**CITY PLAN COMMISSION****THURSDAY, MAY 22, 2025****FILE NUMBER:** S245-149**SENIOR PLANNER:** Hema Sharma**LOCATION:** C F Hawn Freeway, east of Silverado Drive**DATE FILED:** April 23, 2025**ZONING:** CS**CITY COUNCIL DISTRICT:** 8**SIZE OF REQUEST:** 4.330-acres**APPLICANT/OWNER:** Ross Capital Ventures, LLC

**REQUEST:** An application to create one 4.330-acre lot from a tract of land in City Block 8798 on property located on C F Hawn Freeway, east of Silverado Drive.

PRELIMINARY PLAT  
**DFW TRUCK PARKING**  
**LOT 1, BLOCK 1/8798**  
 BEING PART OF CITY BLOCK 8798  
 SITUATED IN THE  
 MCKINNEY & WILLIAMS SURVEY  
 ABSTRACT NO. 1022  
 CITY OF DALLAS, DALLAS COUNTY, TEXAS  
 CITY PLAN FILE NO. 5245-149  
 ENGINEERING PLAN NO. DP \_\_\_\_\_

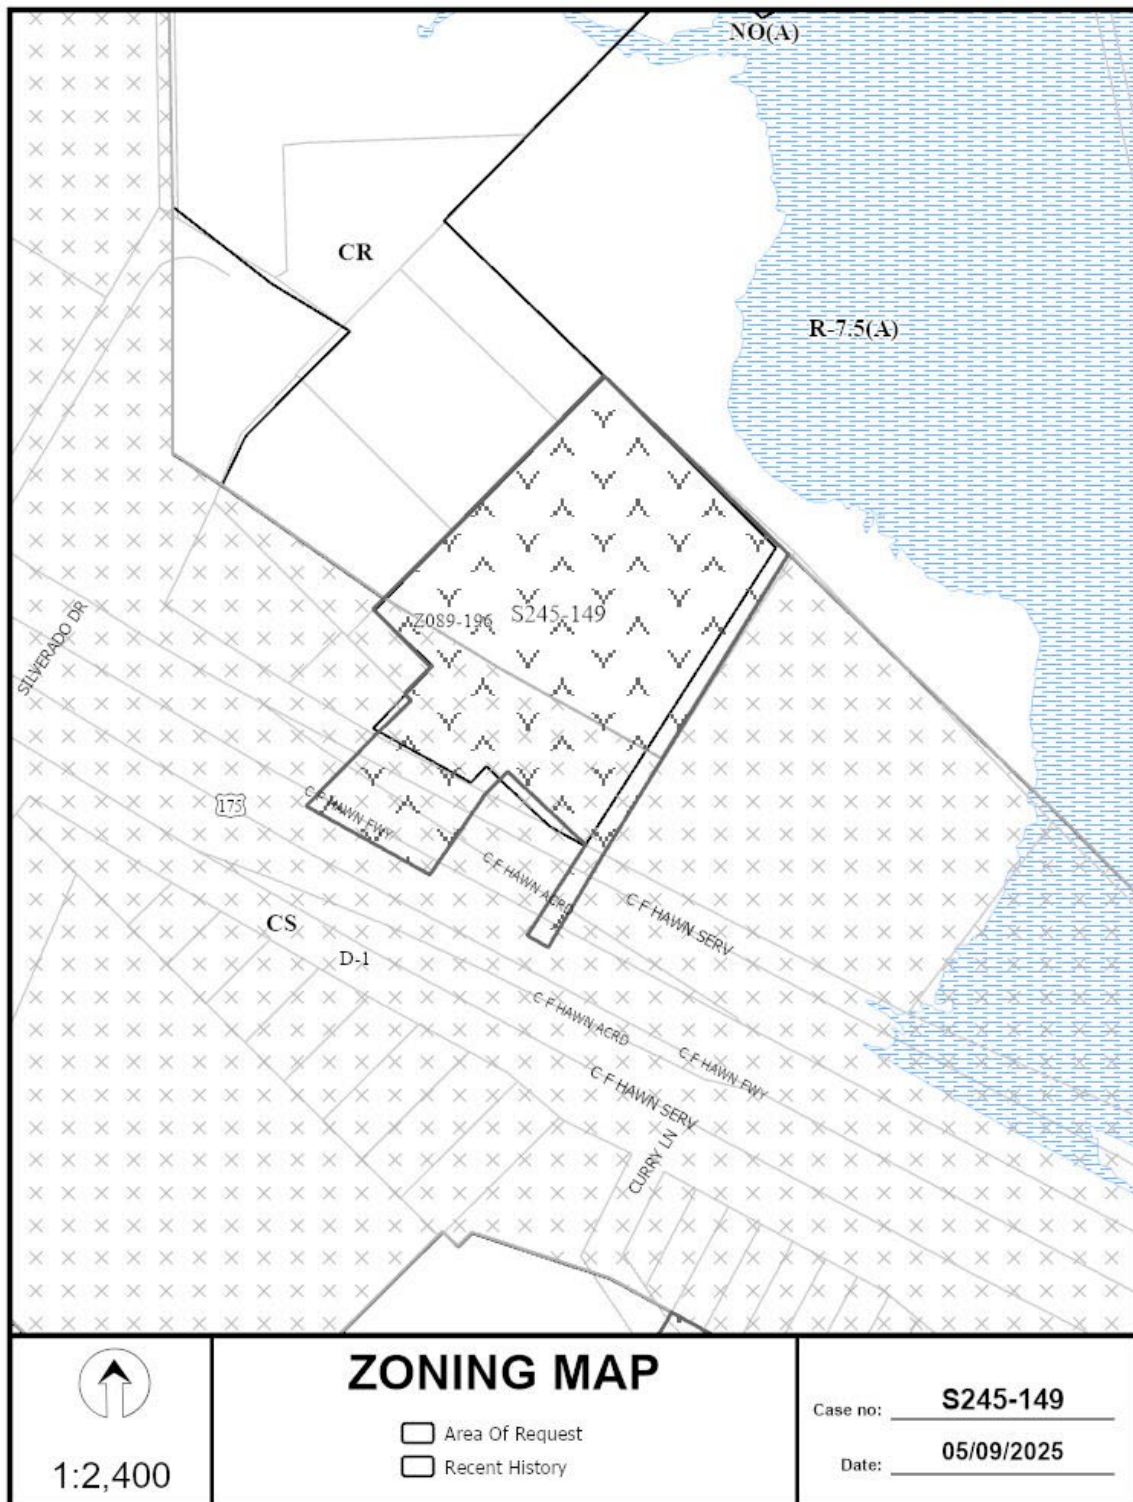
15. On the final plat, add the note: "TxDOT approval may be required for any driveway modification or new access point(s)."

16. Prior to final plat, submit a completed final plat checklist and all supporting documents.

17. Engineer must furnish plans for water and sanitary sewer. Developer must furnish a contract for water and sanitary sewer. Sections 49-60(g)(1) and (2) and 49-62(b), (c), and (f).
18. Additional design information is required for assessment. Site plan must be submitted showing proposed development, building finished floor elevation, development, existing mains – including downstream manhole, and proposed water and wastewater service locations. Submit water/wastewater engineering plans to 320 E. Jefferson Blvd., Room 200, Attention: Water and Wastewater Engineering.
19. Wastewater main improvements is required by Private Development Contract. Submit water/wastewater engineering plans to 320 E. Jefferson Blvd., Room 200, Attention: Water and Wastewater Engineering.

20. On the final plat, identify the property as Lot 1 in City Block B/8798.
